**CITY COUNCIL AGENDA ITEM**

**AGENDA ITEM:**    **201402052** - 120 & 130 West Wieuca Road, *Applicant: JW Homes, LLC*, to rezone the subject property from A-O (Apartment Office District) conditional to A (Medium Density Apartment District) for the construction of a townhouse development, with concurrent variances

To: John McDonough, City Manager  
From: Angela Parker, Director of Community Development   
Date: November 6, 2014 for submission onto the November 18, 2014 City Council meeting  
Agenda Item: 201402052 120 and 130 West Wieuca Road

**DEPARTMENT OF COMMUNITY DEVELOPMENT RECOMMENDATION**

**SITE PLAN**  
WEST WIEUCA (CONCEPT 15.1)  
120 & 130 WEST WIEUCA ROAD  
LAND LOT 94, 17TH DISTRICT  
FULTON COUNTY, GEORGIA

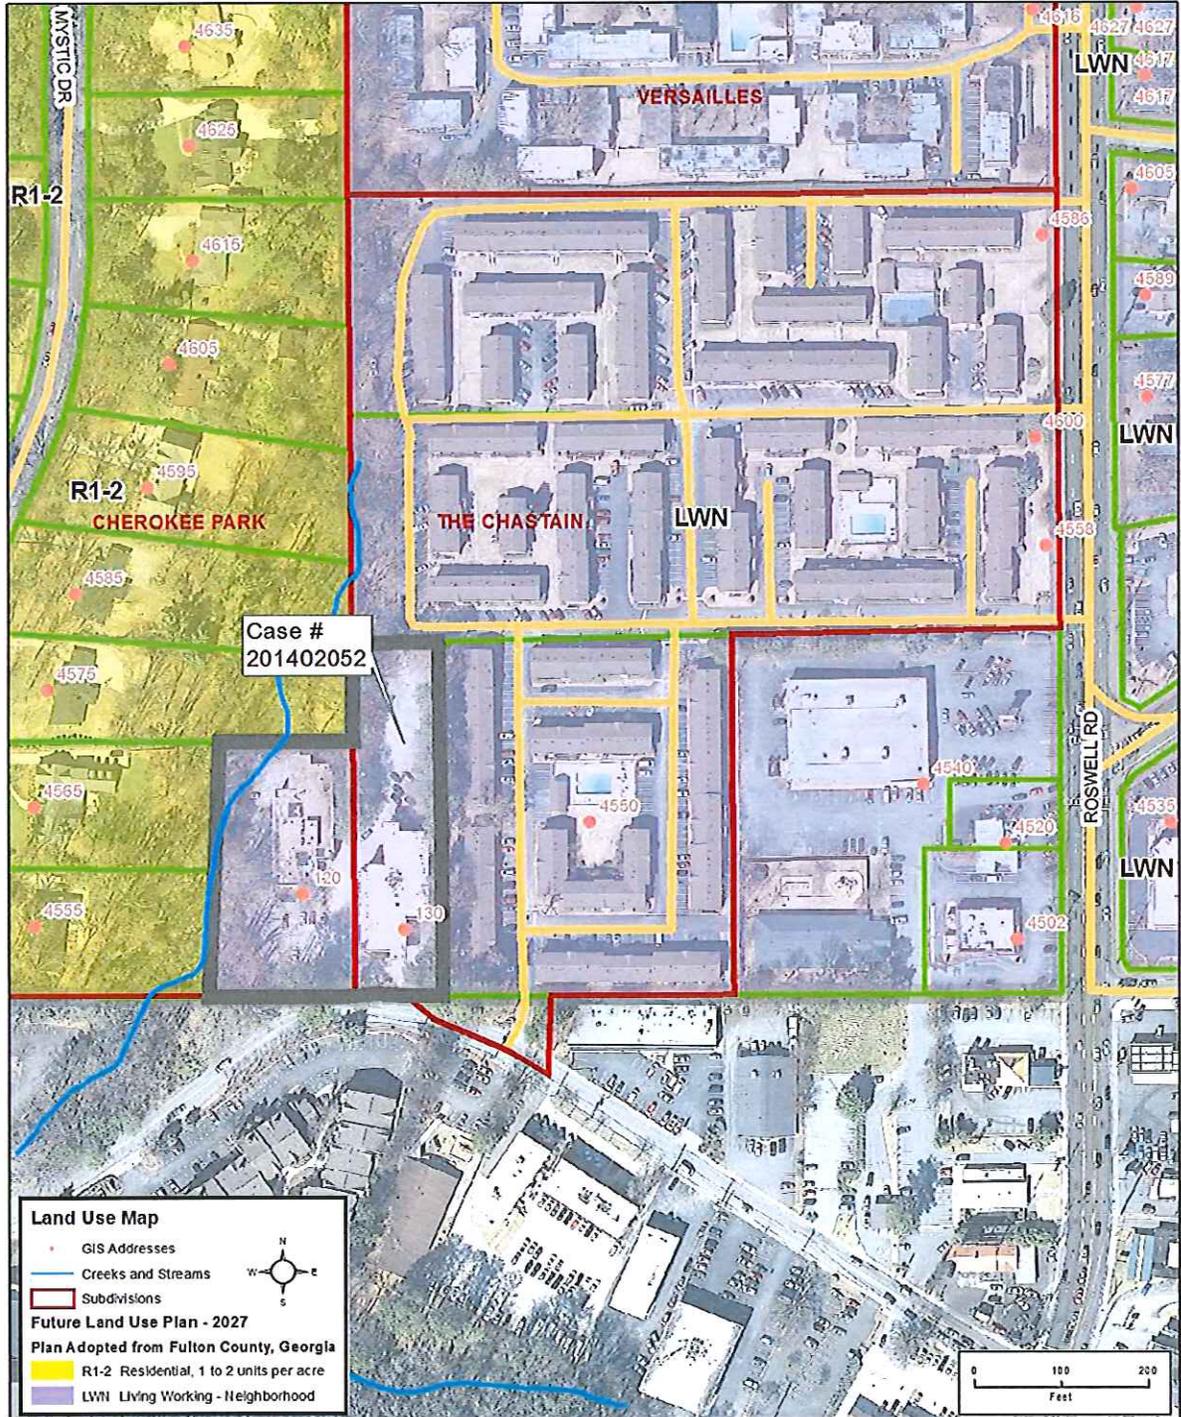
All encroachments are labeled on the site plan dated received November 4, 2014. There is an overall reduction of 1,495 square feet of impervious surface in the stream buffer. Based on these reasons, staff is of the opinion this condition not has been satisfied.

All streams on the property have been identified on the site plan. The stream buffer covers approximately 20% of the property with a stream running north to south along the western side of the property.

All buffer and setback intrusions have been identified on the site plan. The applicant is proposing to construct townhomes and driveway in the stream buffers.

Alternative designs have been discussed with the staff regarding the proposed building and driveway location. The applicant has added pervious paver in location where driveways encroach into the stream buffer. Therefore, staff is of the opinion this condition has not been satisfied.

2. To the owner's agreement to abide by the following:
  - a. To the site plan received by the Department of Community Development dated November 4, 2014. Said site plan is conceptual only and must meet or exceed the requirements of the Zoning Ordinance and these conditions prior to the approval of a Land Disturbance Permit. The applicant shall be required to complete the concept review procedure prior to application for a Land Disturbance Permit. Unless otherwise noted herein, compliance with all conditions shall be in place prior to the issuance of a Certificate of Occupancy.

- i. To reduce the stream buffer to allow the encroachments as shown on the site plan dated November 4, 2014 (CV201402052 #6)
- j. Residential units shall have a height limit of forty (40) feet.
- k. There shall be no common trash dumpsters. Trash shall be picked up from individual units one day per week.
- l. Building lighting shall not be located above the first floor except Coach lights at the back doors of units which shall be screen and directed downward.
- m. Building exterior treatments shall be brick and/or stone.
